: Fwd: 1809 Cinnamon Path

Subject: RE: [1809 Cinnamon Path](#)

Attached is the zoning report for the property.

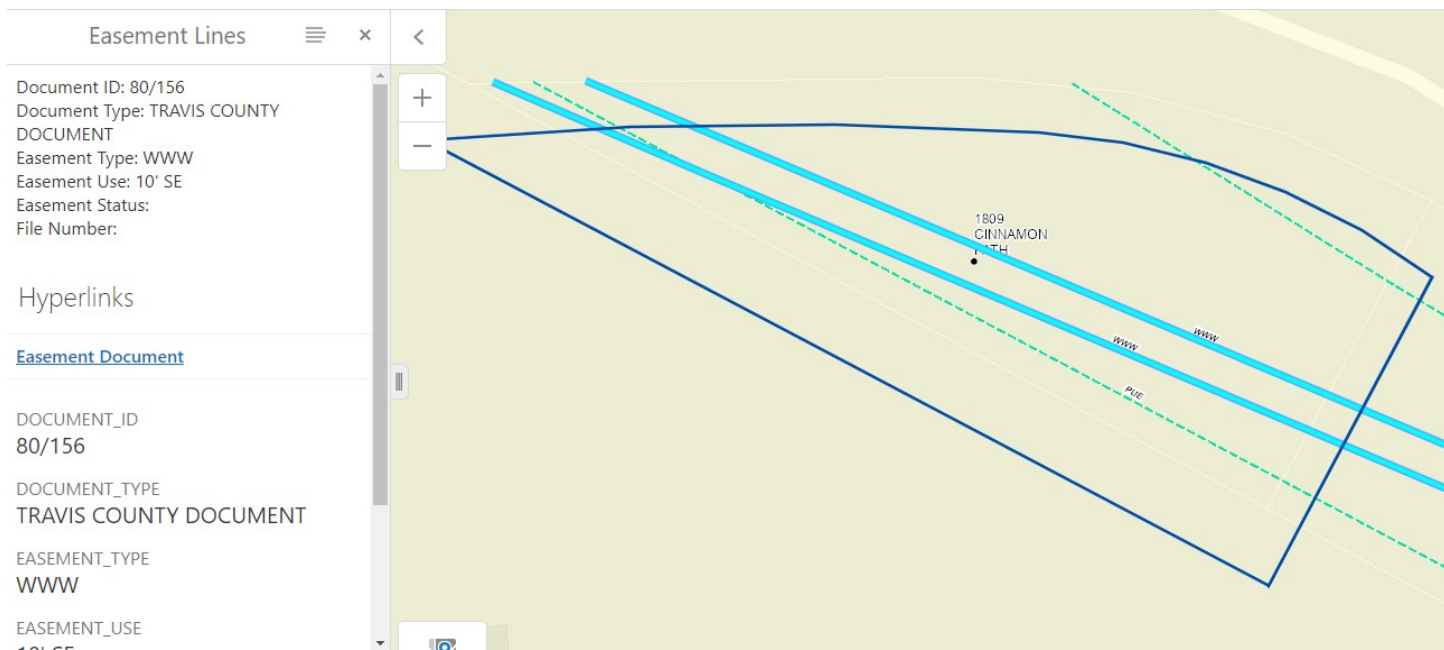
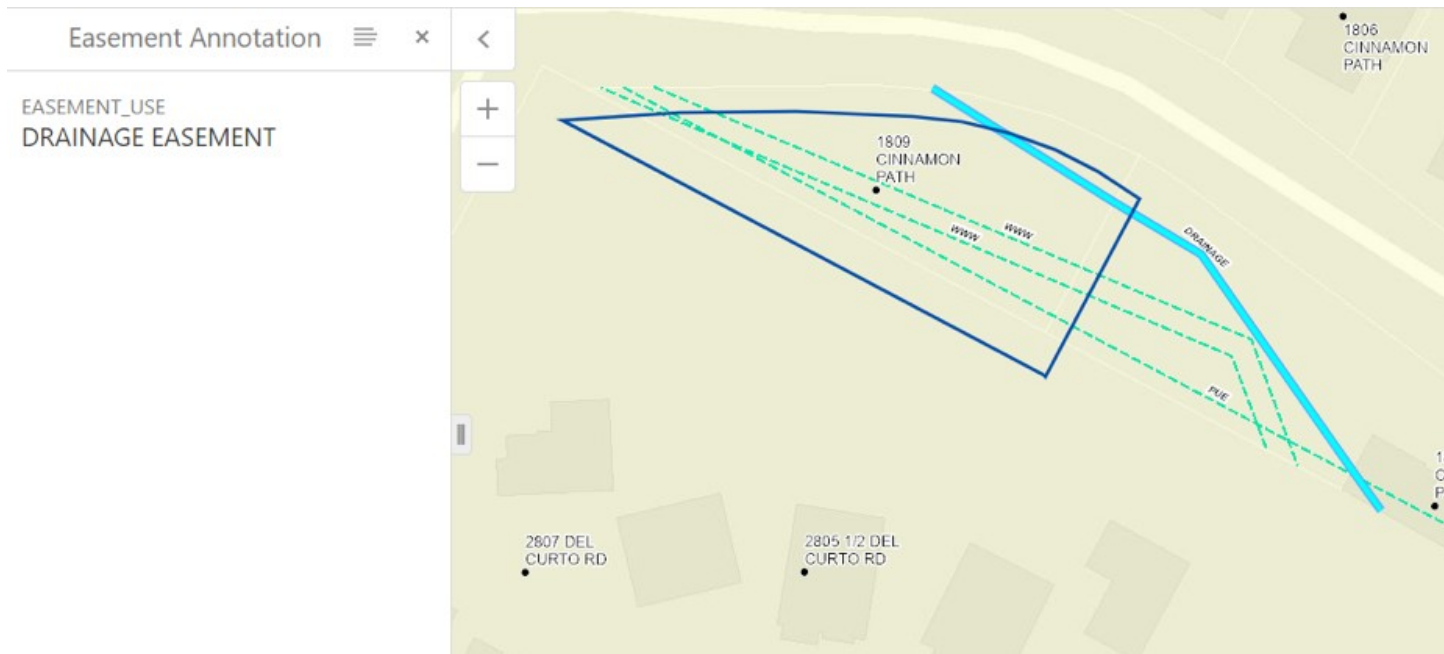
Minimum zoning requirements for an SF-3 can be found here https://library.municode.com/tx/austin/codes/land_development_code?nodeId=TIT25LADE_CH25-2ZO_SUBCHAPTER_CUSDERE_ART2PRUSDERE_DIV1RETA_S25-2-492SIDERE

EASEMENT_USE
7.5'/10' PUE

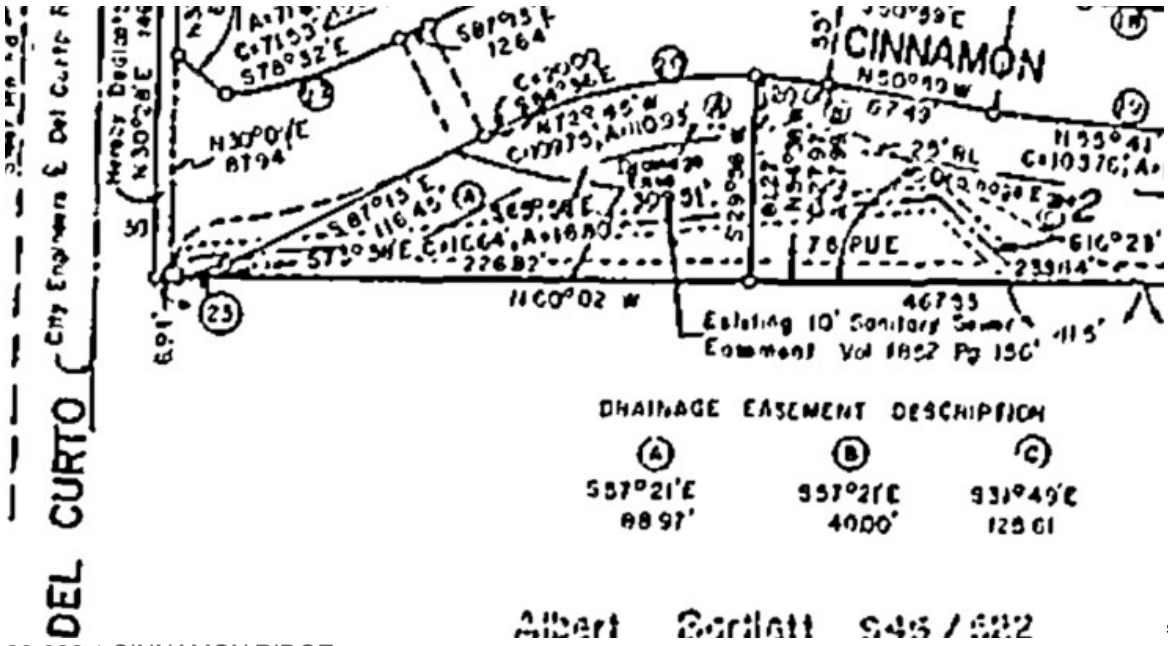
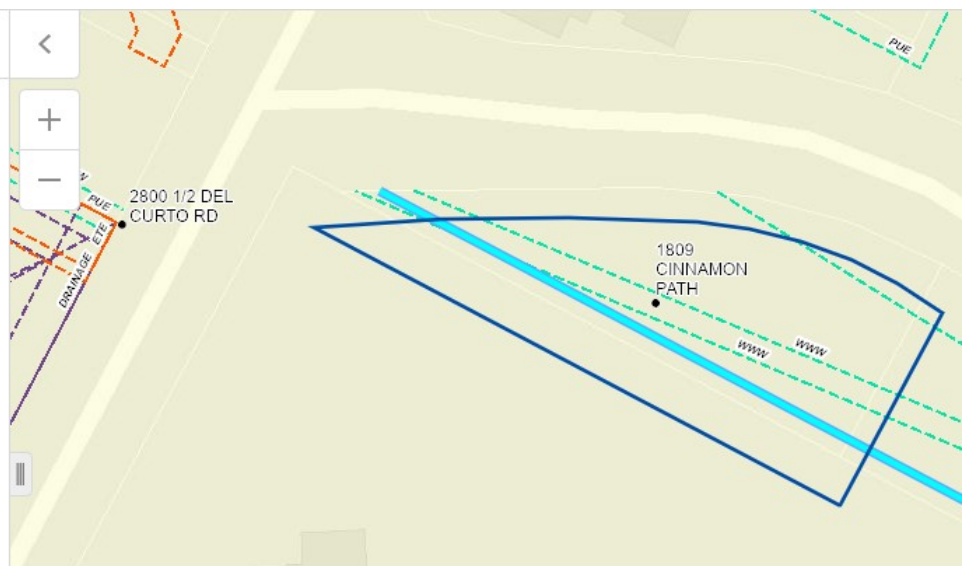
No buildings or eaves are permitted to encroach into easements. Please see the easements below. Please reach out to the Office of Real Estate Services to have the easements released. You may contact the Office of Real Estate at the following email: LandManagement@austintexas.gov

The exact easement locations will need to be provided on a registered survey. Our property profile website is not accurate when it comes to the locations of easements.
